**CANADIAN MUSEUM OF IMMIGRATION  
AT PIER 21 - EXPANSION**

Halifax, Nova Scotia  
Project #: 13-005  
Aug 08, 2014

**ADDENDUM 03**

SECTION DETAIL AT STAINLESS PANELS	SCALE: 1/4" = 1'	SK-1 2B/A1.7.0
	DRAWN BY: WE	
	DATE: 2014.07.30

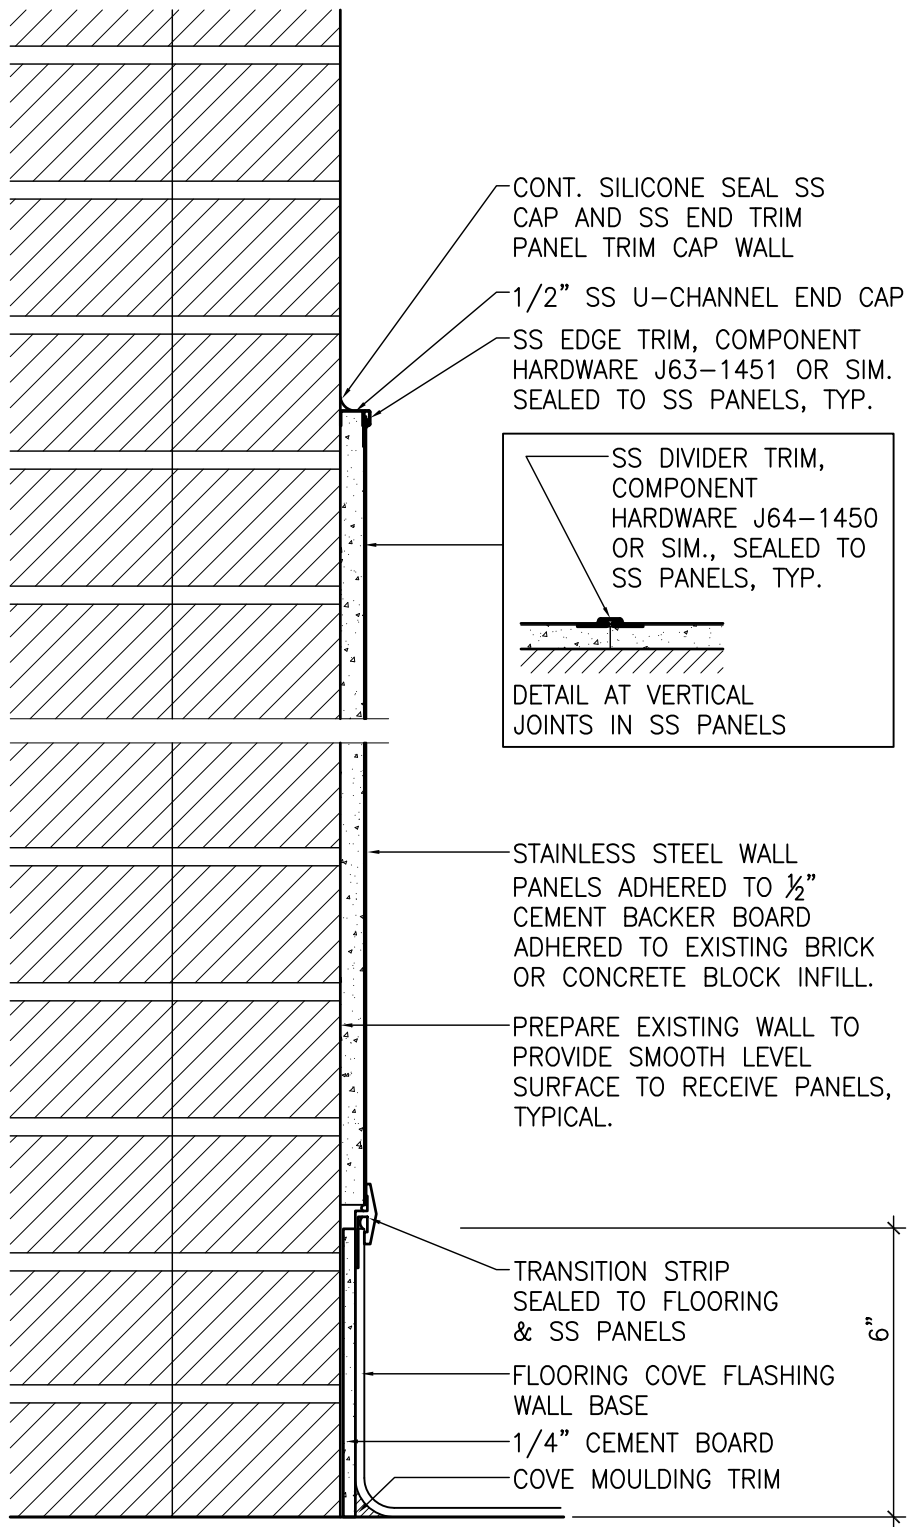
- Stainless steel wall panels are 20-gauge stainless steel, type 304, no. 4 finish, 180 grit, 48" wide sheets. All finish lines to run vertically. See Attached SK-1 2B/A1.7.0 for typical side and divider trim pieces. The panels and trims to be adhered with heat resistant mastic to smooth 1/2" cement board backing adhered level to existing brick wall. Supplement backing securement with mechanical fasteners as required. Clean and condition substrates as required to provide smooth, flush and plumb surfaces; remove high spots and fill low spots. The stainless steel panels to be installed from typical base (refer to detail 2B/A1.7.0) to minimum 1" above finished fume hood level. Heat resistant sealants to be used at trim, top, base and divider trims to seal panels.

- Clarification: the metal wall covering base detail 3/A1.7.0 is for the Metal Wall Coverings only, not stainless steel panels.
- Revise detail reference on drawings 1/A1.2.1 and 4/A1.4.3 for stainless steel panels (grid 43 C-D) from 2/A1.7.0 to 2B/A1.7.0.
